**Project No: 10066**

**Re: Residential development and strata subdivision consisting of four sole-occupancy units with associated carparking, storage space, and four (4) swimming pools – 9-11 Birdwood Avenue, Collaroy NSW 2097**

#### **BCA Compliance Capability Statement – DA Submission**

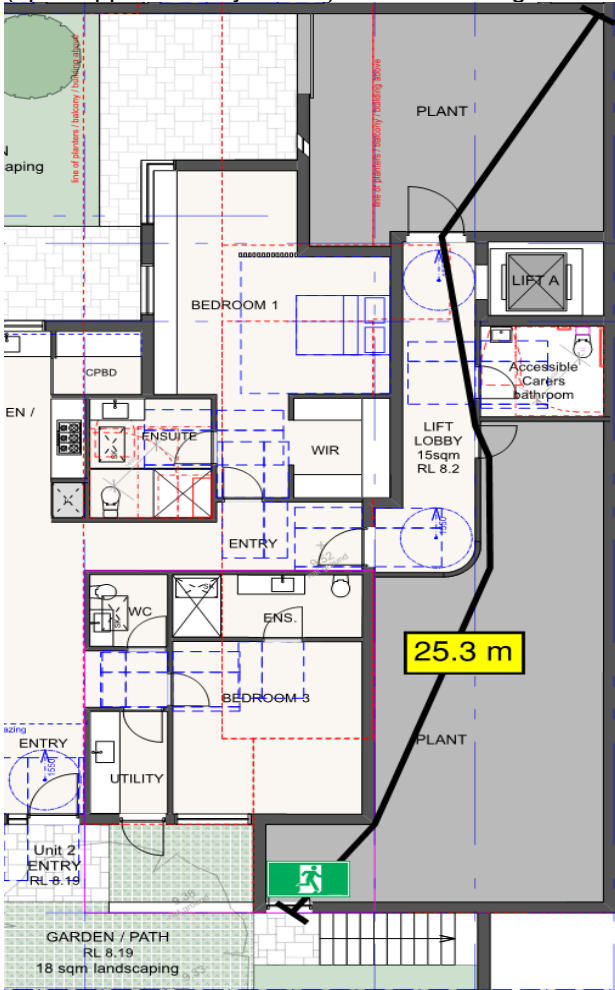
BCA Clause	Deemed-to-Satisfy Provision to be addressed
Clause C2.8	On basement level the storage area must be fire separated from the carpark by construction achieving an FRL not less than 240 minutes.
Clause C2.9	The floor between adjoining parts, with different classification, must have an FRL of not less than that prescribed in Specification C1.1 for the classification of the lower storey.
Clause C3.2	Openings in the external wall of Units 1 and 3 are within 3m of the fire-source feature.
Clause D1.4	<p><b>Basement –</b> The distance of travel to the point of choice from the basement carpark exceeds 20m (up to approximately 26.6m). Refer to the figure below.</p>  <p>The diagram is a detailed basement floor plan. It shows four residential units (Unit 1, Unit 2, Unit 3, Unit 4) arranged around a central carpark area. Unit 1 and Unit 3 are on the left, while Unit 2 and Unit 4 are on the right. Each unit has a carpark space. To the left of the units are plant rooms and a pool area. To the right are common area storage and basement storage areas. A yellow box with the text '26.6 m' is placed in the carpark area, with a line indicating the distance from the carpark to the point of choice. The plan also shows various storage areas, including 'COMMON AREA STORAGE' and 'BASEMENT STORAGE'. A 'POOL ABOVE UNIT 2' is indicated. The plan includes dimensions for the units and carpark spaces, and a scale bar is provided.</p>

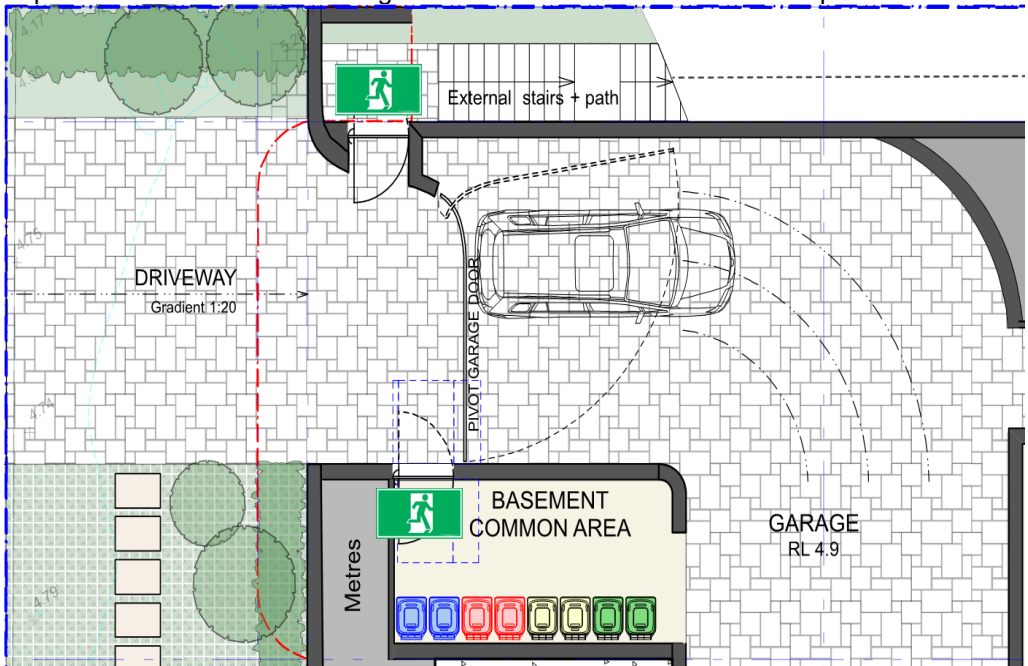
BCA Clause	Deemed-to-Satisfy Provision to be addressed
	<p><u>Lower Ground –</u> The distance of travel to the exit from the plant room on Lower Ground exceeds 20m (up to approximately 26.6m). Refer to the figure below.</p> 
D1.10(a)	<p>The exit may be blocked at the point of discharge. Suitable barriers are to be provided to prevent vehicles from blocking the exit or access to it. Refer to the photo below.</p>

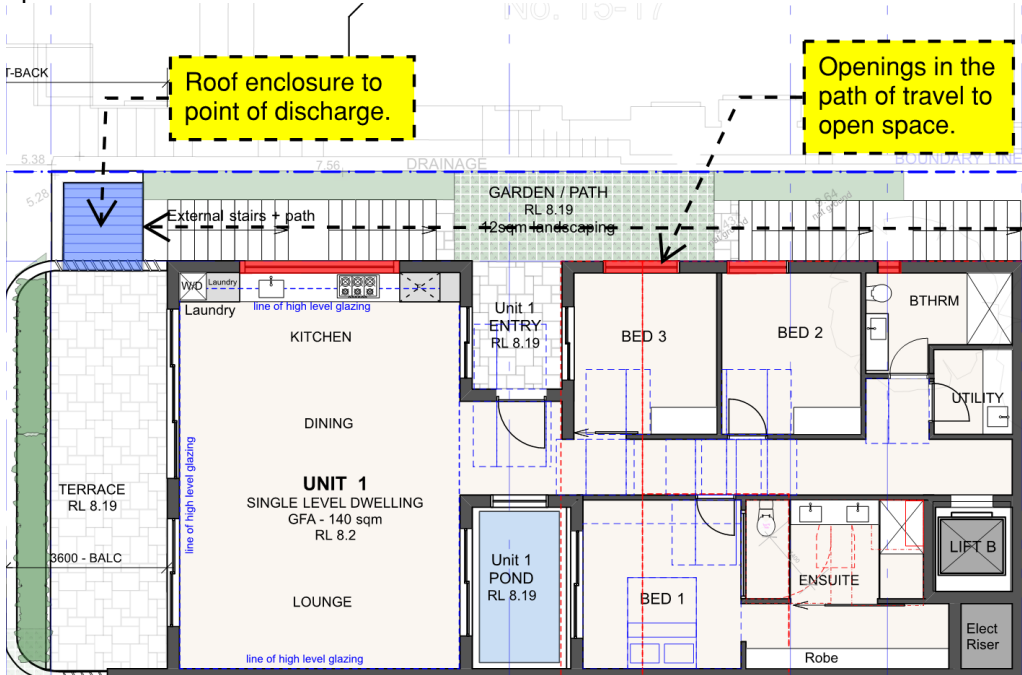
BCA Clause	Deemed-to-Satisfy Provision to be addressed
D1.10(c)	<p>The external stairway, i.e. exit, serving the residential sole-occupancy units on Lower Ground and Ground Level, does not discharge to a space on the allotment that is adequately protected from fire and open to the sky i.e. open space. Refer to the mark-up below.</p>
